UNITED STATES PATENT AND TRADEMARK OFFICE

APPLICATION NO.	FILING DATE	FIRST NAMED INVENTOR	ATTORNEY DOCKET NO.	CONFIRMATION NO.
09/924,004	08/07/2001	Alexander S. Perel	00-SM6-262	1920

Office Action Summary

DETAILED ACTION

Horsky discloses an ion source (FIG. 2, element 58) for an ion implanter, comprising:

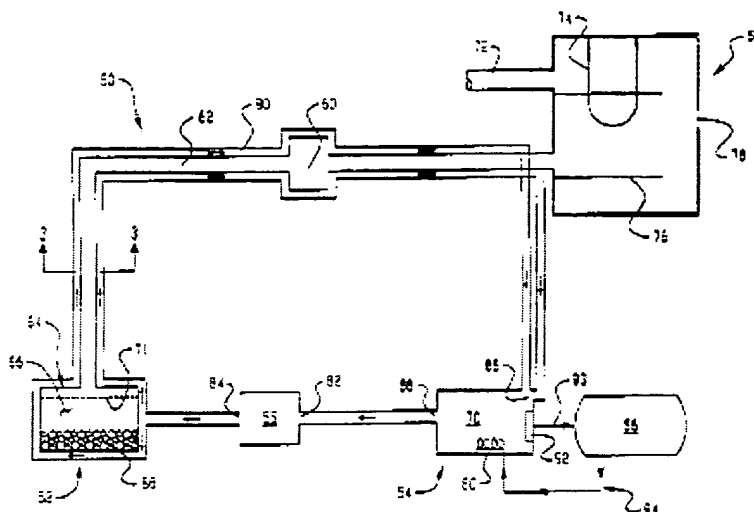
1. Claims 1, 2, 3, 6, 7, 9-11, 14, 15 are rejected under 35 U.S.C. 103(a) as being unpatentable over Horsky (US 6107634) in view of Foad (US 5977552).

a sublimator (FIG. 2, element 52) having a cavity (FIG. 2, element 66) for receiving a source material (FIG. 2, element 68) to be sublimated and for sublimating the source material;

an ionization chamber (FIG. 2, element 58) for ionizing the sublimated source material, said ionization chamber located remotely from said sublimator (FIG. 2); and

a feed tube (FIG. 2, element 62) for connecting said sublimator (FIG. 2, element 52) to said ionization chamber (FIG. 2, element 58).

Referring to claims 2, 10: further comprising a heating medium (FIG. 2, element 70) for heating at least a portion of said sublimator (FIG. 2, element 52) and said feed tube (FIG. 2, element 62), and a control mechanism for controlling the temperature of said heating medium (FIG. 2, element 70).

Referring to claims 3, 11: wherein said control mechanism comprises a heating element (FIG. 2, element 80) for heating the heating medium (FIG. 2, element 70), a pump (FIG. 2,

element 55) for circulating said heating medium, at least one thermocouple (FIG. 2, element 92) for providing temperature feedback from said heating medium (FIG. 2, element 70), and a controller (FIG. 2, element 56) responsive to said temperature feedback to output a first control signal (FIG. 2, element 94) to said heating element.

Horsky does not disclose the comprising of a gas injector for injecting gas into said cavity.

However, Foad discloses an ion source for ion implantation apparatus that comprises a gas injector (FIG. 2, element 61) for injecting gas into a cavity of a crucible (FIG. 2, element 40).

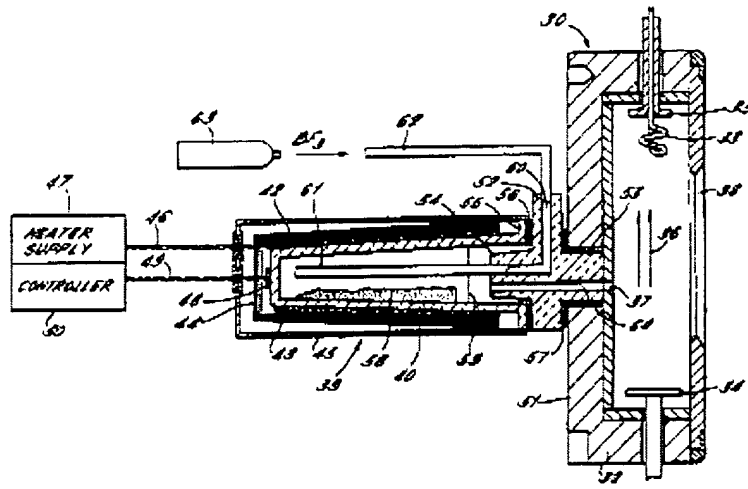
Therefore, it would have been obvious for one having ordinary skill in the art at the time the invention was made to include the gas injector for injecting gas as disclosed by Foad into the cavity of the crucible disclosed by Horsky. The motivation of doing so is to achieve higher proportion of ions extracted from the arc chamber in order to gain the beam current implanted on the target substrate as taught by Foad (column 8, line 10-16).
